rLoop — Stepper Node
Accelerometers
Original Author: SafetyLok

DESIGN REVIEW NOTES:

rLoop — Stepper Node Mux Priority Watchdog System Original Author: SafetyLok Sheet: /Sheet_Watchdog/ File: StepperNode_Watchdog.sch Title: Watchdog Size: A3 Date: KiCad E.D.A. kicad 4.0.2-stable

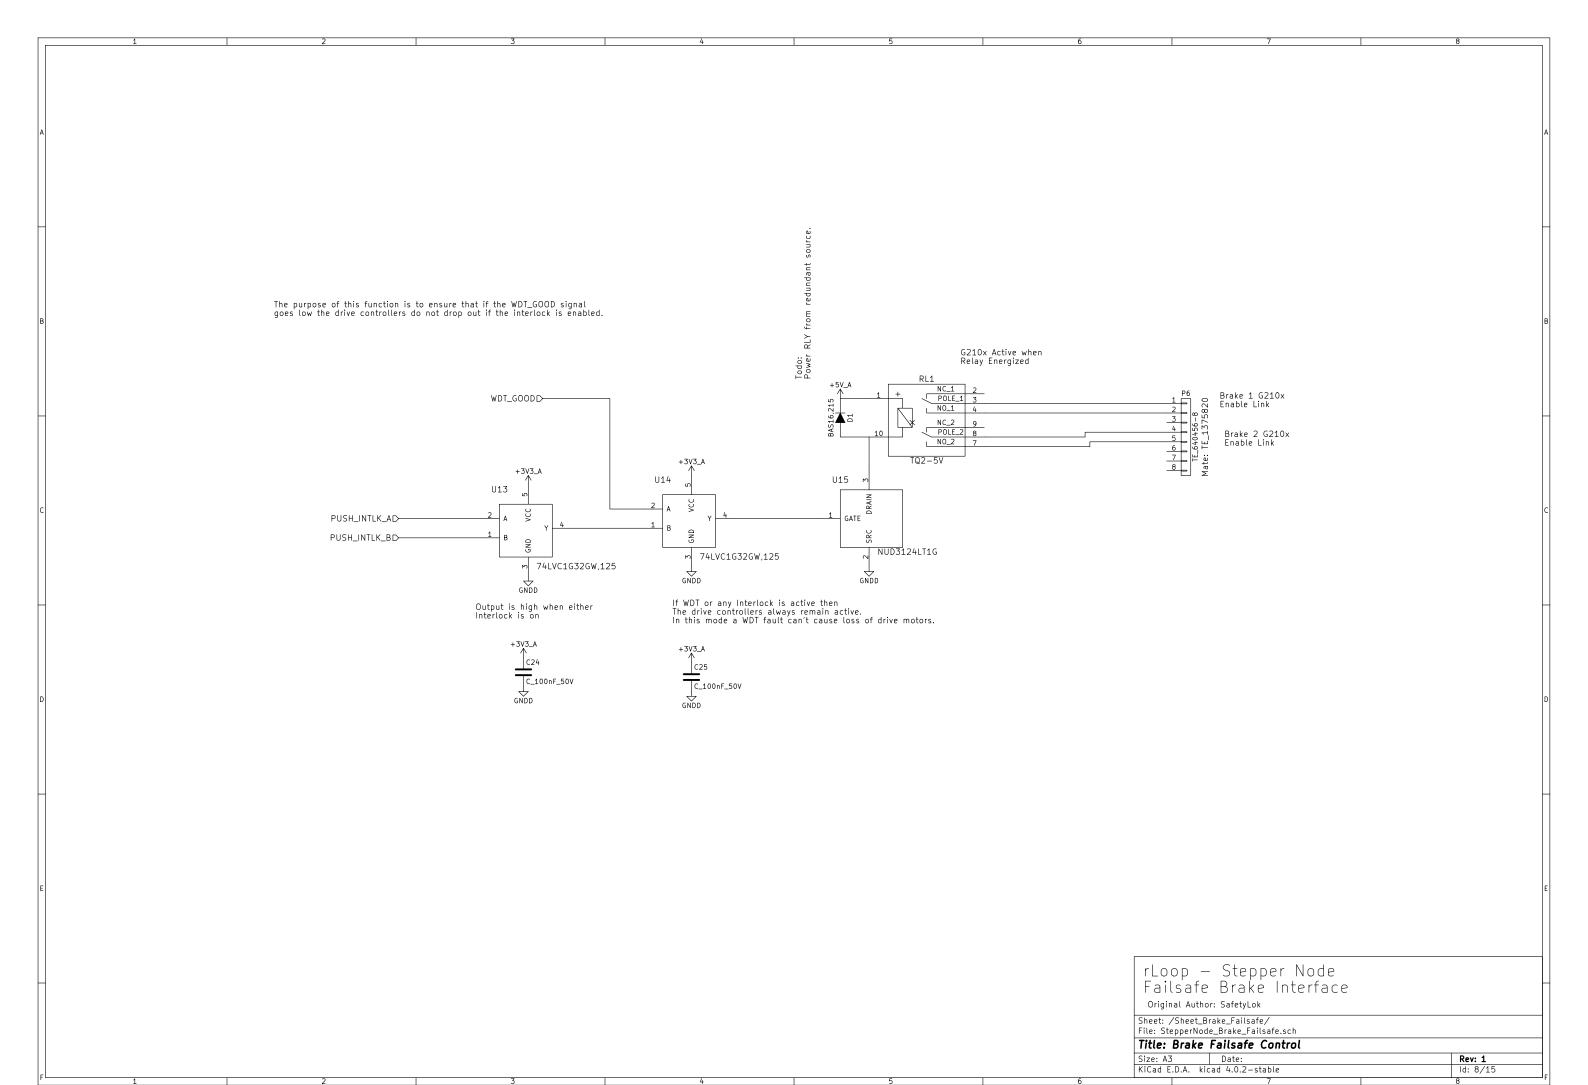
4. Need to provide isolation in case of parasitic power from a failed node.

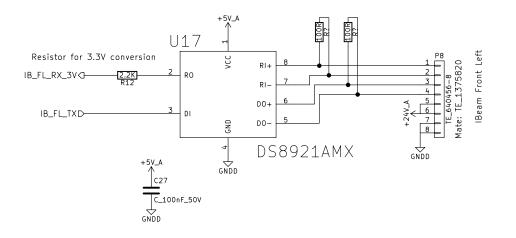
2. STEP_DIR_CTRL is pulled up, so the only way it can go low is if the TPS3813 is powered

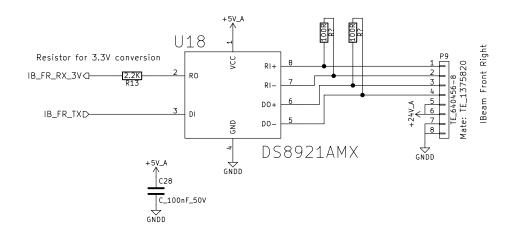
3. All devices here need redundant supplies
